UNITED STATES PATENT AND TRADEMARK OFFICE

APPLICATION NO.	FILING DATE	FIRST NAMED INVENTOR	ATTORNEY DOCKET NO.	CONFIRMATION NO.
09/673,738	10/20/2000	Fumio Takahashi	Q61378	3763

Office Action Summary	Applicati n No.		Applicant(s)	
	09/673,738		TAKAHASHI, FUMIO	
	Examiner		Art Unit	
	Steven D. Maki		1733

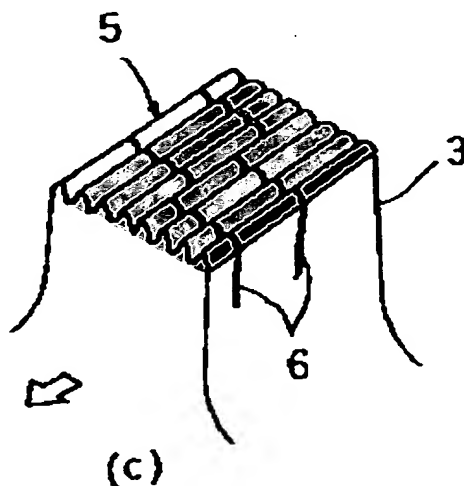
Applicant argues that the block structures of the claimed invention and Japan '810 are different in structure. The examiner disagrees. The block of Japan '810 includes "a peripheral protuberant portion" along an edge of the block. See for example figure 6(a) or figure 6(c). An enlarged copy of figure 6(c) of Japan '810 is provided below:

The yellow and orange coloring was added by the examiner to facilitate discussion of the teachings of Japan '810. A "peripheral protuberant portion" (a relatively small rib) along an edge of the block in figure 6(b) is indicated in orange. As can be seen from figure 6(b), the upper surface of the orange peripheral protuberant portion is rounded. The round shape of the orange peripheral protuberant portion (the round top of the relatively small rib) causes the height of the block to decrease toward the block end

edge and toward a central portion of the block. The claimed peripheral protuberant portion reads on the above note peripheral protuberant portion (small rib) of Japan '810 – applicant having presented no convincing argument and/ or evidence to the contrary. As acknowledged in the last office action, the block of Japan '810 has a multitude of relatively small ribs. However, as noted in the last office action, claim 8 fails to exclude a multitude of relatively small ribs (protuberant portions) arranged over the entire top surface of the block as shown in figures 6a or 6c of Japan '810. In other words, claim 8 fails to exclude the yellow relatively small ribs. Applicant contrasts unique sloped configuration v. simple notches and roughness shapes but fails to explain why the language in claim 8 excludes a multitude of relatively small ribs (protuberant portions) arranged over the entire top surface of the block as shown in figures 6a or 6c of Japan '810.
